FED. ROAD DIST. NO.	STATE	PROJ. NO.	FISCAL YEAR	SHEET NO.	TOTAL SHEETS
HAWAII	HAW.	36AB-01-04M	2004	ADD.18	<i>54</i>

GENERAL NOTES **♦ TYPICAL**INSTALLATION DETAILS

HANA HIGHWAY RESURFACING
Haleakala Highway to Hookipa Park

Project No. 36AB-01-04M

TYPICAL INSTALLATION

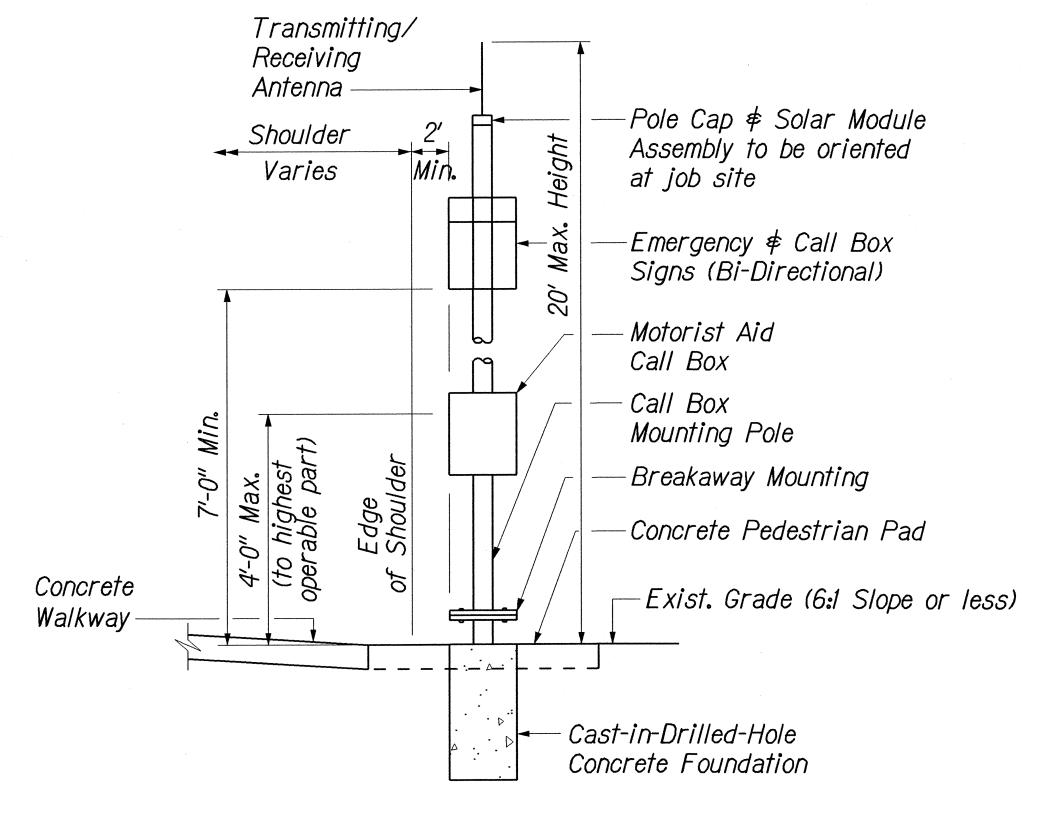
5-27-04 Add General Notes Nos. 7 \$ 8.

- 7. Concrete walkway from pedestrian pad to edge of shoulder shall not exceed a maximum slope of 5% (20:1). See Sheet No. D1 for detail.
- 8. If concrete walkway from pedestrian pad to edge of shoulder exceeds the maximum slope of 5% (20:1), a concrete accessible ramp shall be constructed. See Sheet No. D1 for detail.
